Access Compliance Report Public Rights-of-Way (Curb Ramps)

Main Street: INVERNESS_DR Cross Street: FOSTER_RD Location: S

ADA ID: RPRK211216130140 Ramp Type: Type 1 - Perpendicular Diagonal Initial Pass/Fail: Pass Overall Compliance: No Severity Score: 10

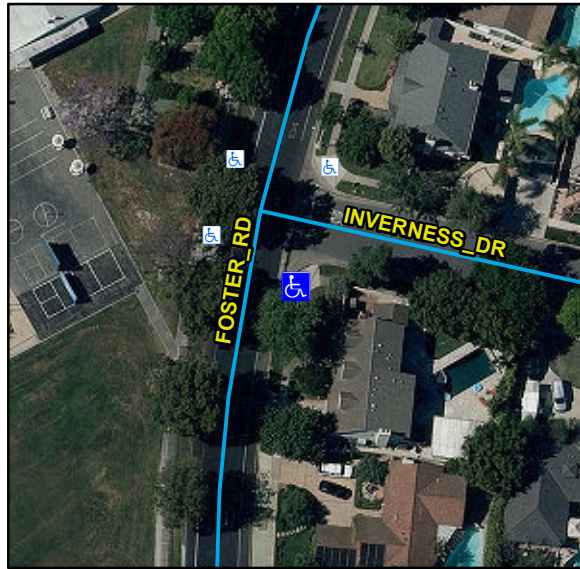
Compliance	Description	Data	Compliance	Description	Data
N/A	Ramp Length (in)	82	N/A	Flare Type LT	
Yes	Ramp Width (in)	48			Sloped
Yes	Ramp Run Slope (%)	7	N/A	Flare Slope LT (%)	6.3
Yes	Ramp Cross Slope (%)	1.2	N/A	Flare Traversable LT	No
N/A	Landing Present	Yes	N/A	Flare Type RT	
N/A	Landing Length (in)	50			Sloped
Yes	Landing Width (in)	48	N/A	Flare Slope RT (%)	2.6
No	Landing Run Slope (%)	2.5	N/A	Flare Traversable RT	No
Yes	Landing Cross Slope (%)	0.7	No	DWS Provided	No
N/A	Landing Movement Obstructed?	No	N/A	DWS Contrast	N/A
	Landing Movement Type	N/A	N/A	DWS Length (in)	N/A
N/A	Landing Shared	No	N/A	DWS Full Width	N/A
N/A	Clear Space	Yes	N/A	DWS Offset Left (in)	N/A
N/A	Clear Space To Crosswalk (in)	48	N/A	DWS Offset Right (in)	N/A
N/A	Marked Crosswalk 1	No	N/A	Marked Crosswalk 2	No
	Crossing 1 Direction	N		Crossing 2 Direction	W
	Marked Crosswalk 1 Width (in)	N/A		Marked Crosswalk 2 Width (in)	N/A

N/A	Ramp Inside Crosswalk 1	N/A	Yes	Ramp Inside Crosswalk 2	N/A
	Crossing 1 Slope (%)	3.9		Crossing 2 Slope (%)	5.6
	Crossing 1 Cross Slope (%)	1.4		Crossing 2 Cross Slope (%)	0.7
No	Gutter Ponding	Yes	Yes	Curb Slope	2.7
No	Gutter Lip Height (in)	0.25		Road Run Slope (%)	0.2
Yes	Gutter Run Slope (%)	0.4		Road Cross Slope (%)	0.5
Yes	Gutter Cross Slope (%)	0.3			
Yes	Overall Surface Condition: Acceptable		No	Perp Joint Present	No
	Cross Gutter Present?	Yes		Spandrel Present?	Yes
	Replace Cross Gutter?	No		Replace Spandrel?	No

Remove & Replace Curb Ramp With Two New Directional Ramps or Equivalent. Grind Gutter Lip.
